CITY OF SYRACUSE, MAYOR BEN WALSH
300 South State Street, Suite 700 Syracuse, NY 13202

Department of Neighborhood and Business Development
 Jake Dishaw, Zoning Administrator
 Office of Zoning Administration – P: (315)448-8640 E: Zoning@syr.gov

<u>SP-23-15</u>	<i>Staff Report – January 22, 2023</i>
Application Type:	Special Use Permit
Project Address:	Unaddressed parking lot for 1117 West Fayette Street (Tax Map ID: 099.-03-02.0)
Summary of Proposed Action:	The applicant proposes to construct a parking lot including 30 vehicle parking and 12 bike parking spaces. The proposed parking lot, which was subdivided off the property situated at 1153-69 W. Fayette St., is exclusively for the proposed multi-unit dwelling development at 1117 West Fayette Street. The reason why this parking lot is currently unaddressed is because the City Assessor has not assigned a new address yet.
Owner/Applicant	Joseph Gehm, 1153 Owner, LLC (Owner) Ryan Benz, 1117 MGMT, LLC (Applicant)
Existing Zone District:	Mixed-Use Transition, MX-3 Zone District
Surrounding Zone Districts:	The neighboring properties to the north are the Light Industry and Employment, LI Zone District. Neighboring properties to the sout

DEMOLITION PLAN
 C-101

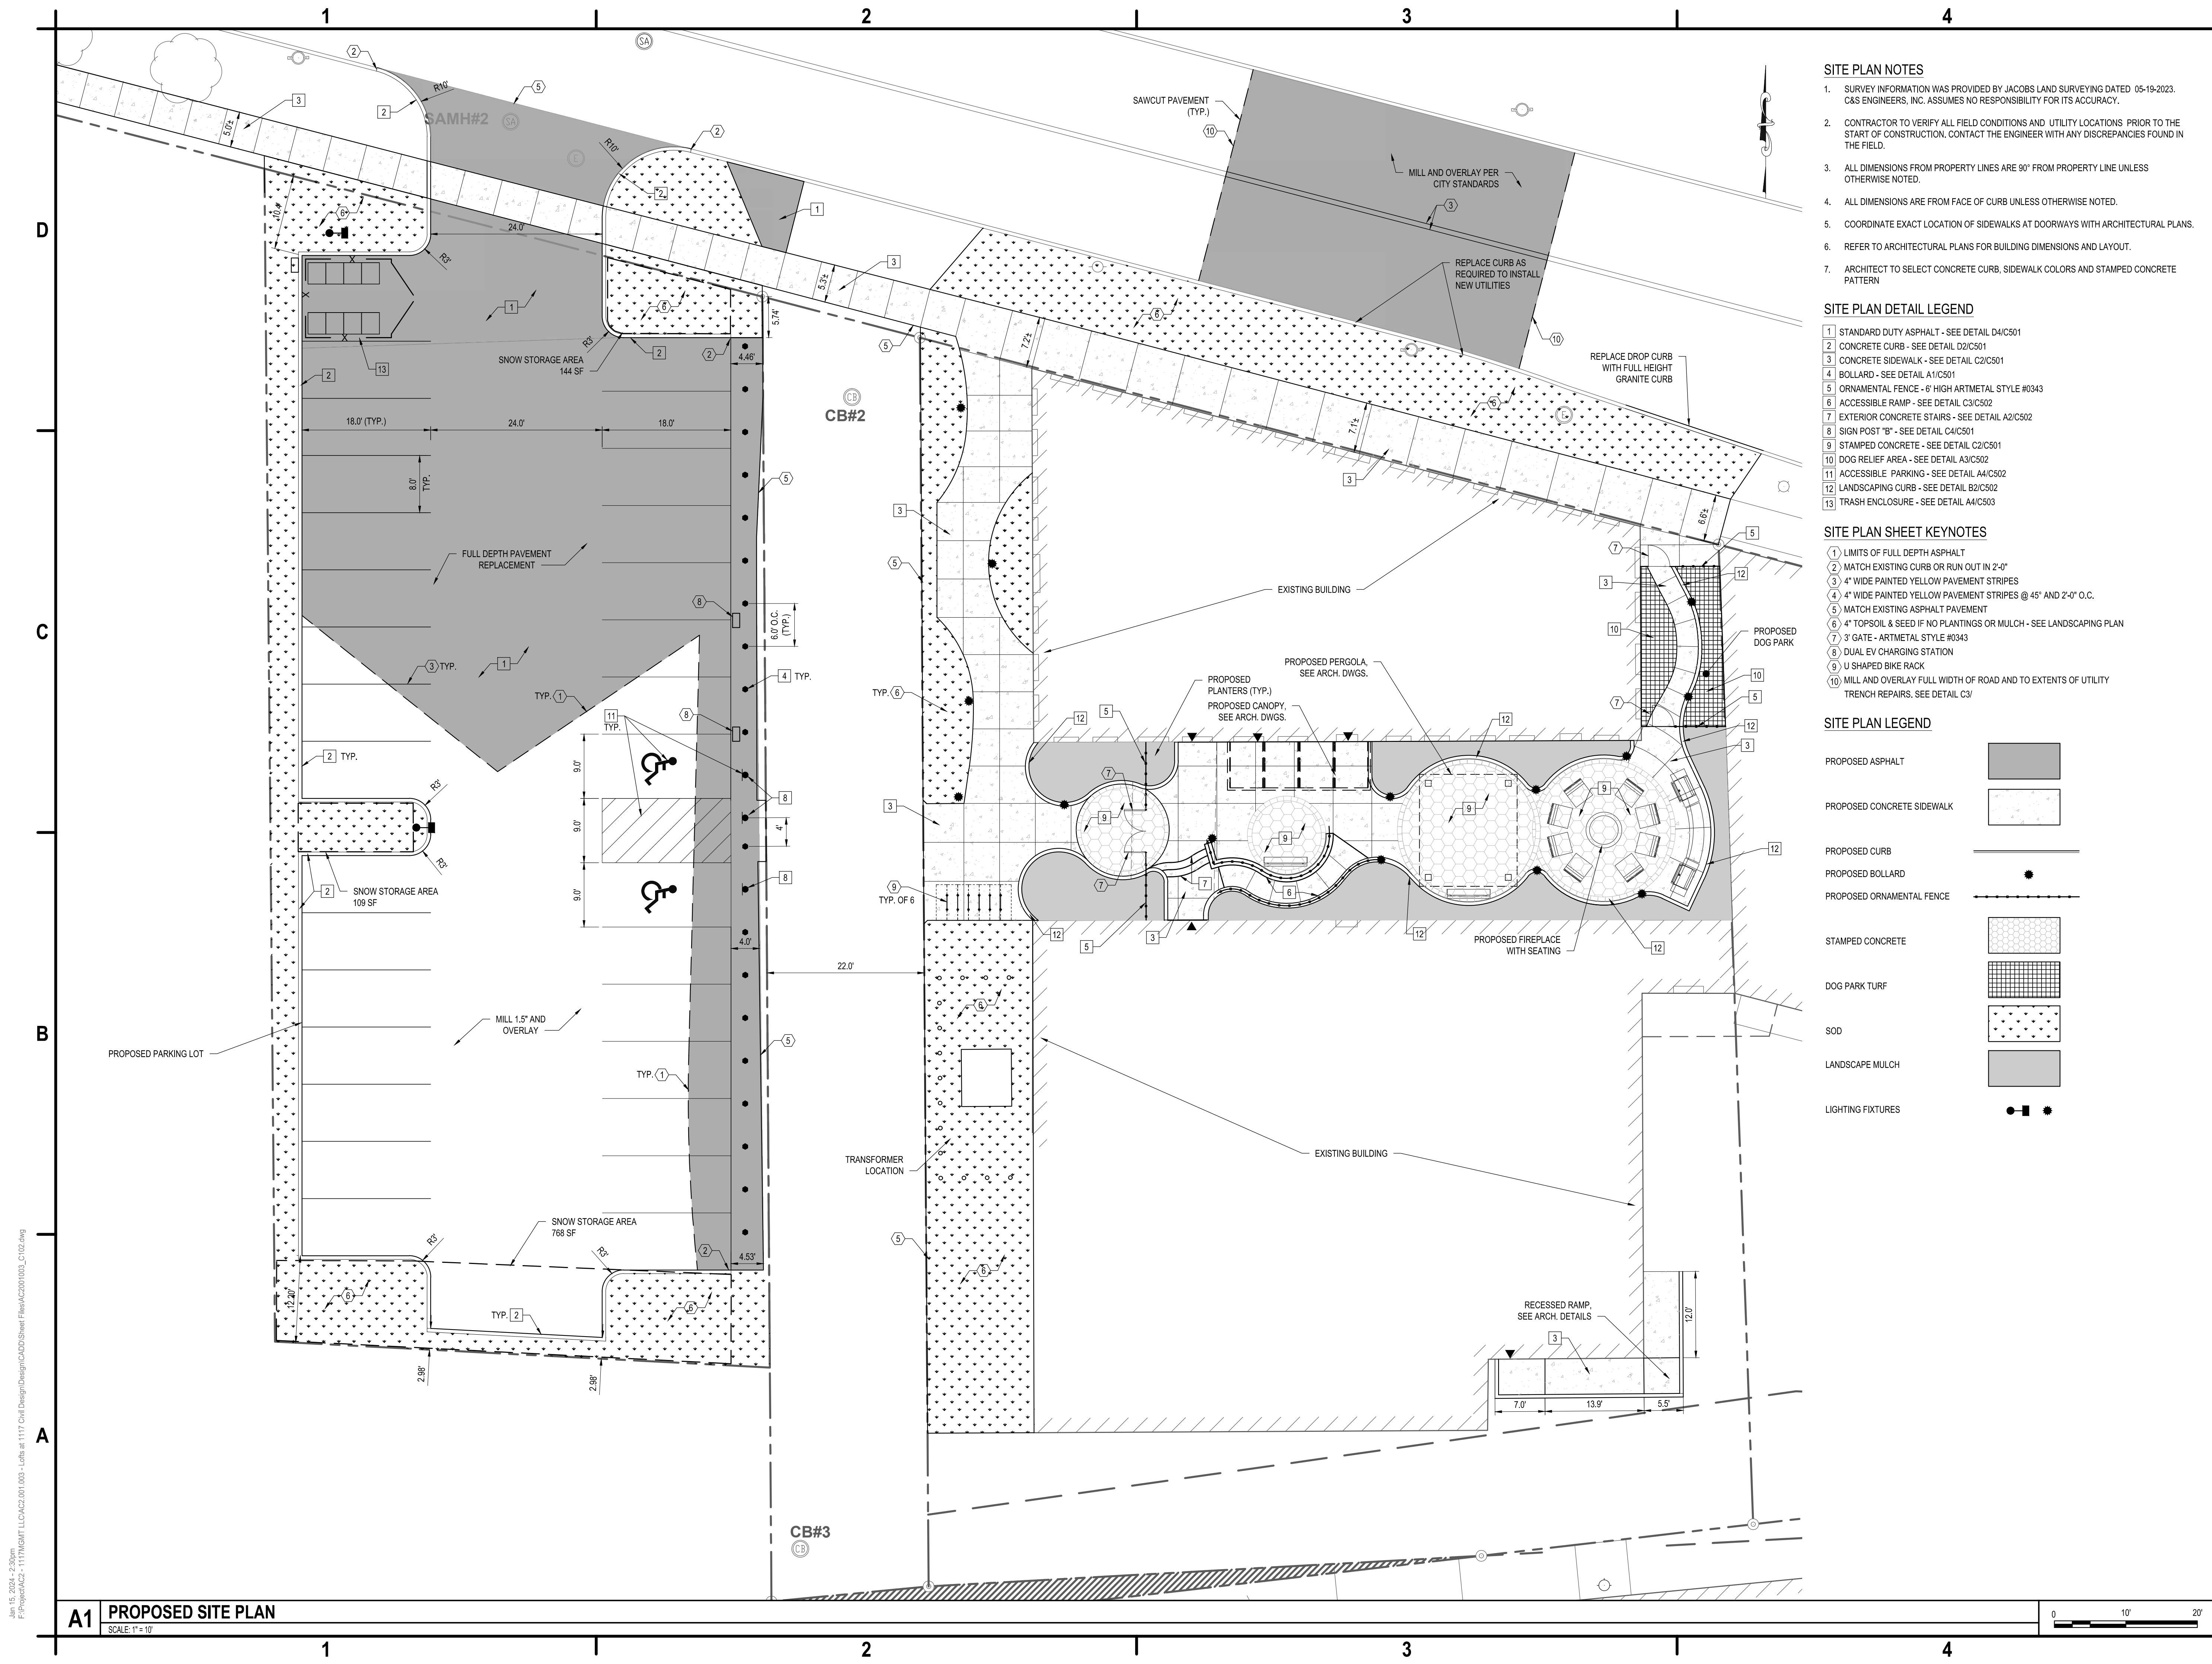
- WHEREAS, per the Demolition Plan dated 11/2023, the proposal is to remove some of the existing asphalt which currently covers the whole of the subdivided lot, replace some of the pavement, construct a 24'-wide driveway onto West Fayette Street, and install lawn or landscaping along the new lot's southern, western, and northern boundaries; the lot will be restriped to have 28 parking spaces; the Site Plan dated 11/2023 shows the lot will provide access to an alley between the
